FIELD CHANGE ORDER	NUMBER: PC736-F001, PC741-F001 PC743-F001, PC744-F001, PC746-F001
--------------------	--

APPLICABILITY: This "F" coded FCO should be installed on DECpc736, 741, 743, 744 and 746 computers at customer sites that require the BIOS support for 5.25", 360KB formatted diskettes. It will upgrade the PCs by replacing the BIOS ROM with revision level 1.22 on the Main Logic Board, P/N 54-22042-01.

Field Installation and verification Procedure for BIOS V1.22

Figure 1: Main Logic Board layout

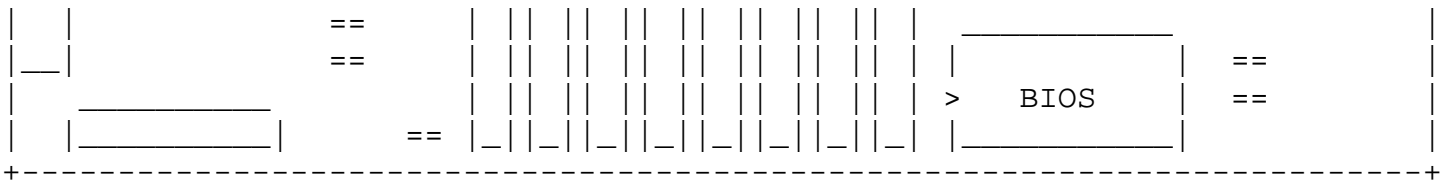
SOLUTION: Replace the BIOS ROM in location E48 on the Main Logic Board 54-22042-01 with BIOS ROM, P/N 23-397E9-00 (BIOS V1.22).

- DECpc LP Rev level is displayed during power up. Refer to sample screen display on Step 10 of suggested installation procedure in this document.
- For spares check the P/N printed on the BIOS ROM located on the Main Logic board (54-22042-01). It should be 23-397E9-00 V1.22, refer to Figure 1 in this document for visual assistance.

- Use the chip extracting tool to remove the old BIOS ROM, pay attention to the chip orientation and make a note of which way the notch is facing. Replace it with the BIOS ROM V1.22 (23-397E9-00) supplied in EQ-01671-01. Pay particular attention to pin alignment and chip orientation when you are replacing the BIOS ROM. The notch on the ROM should face the back of the chassis, refer to Figure 1 on previous page for visual assistance. The notch on the chip is indicated by ">". Check to make sure there aren't any bent pins after you've replaced the chip.
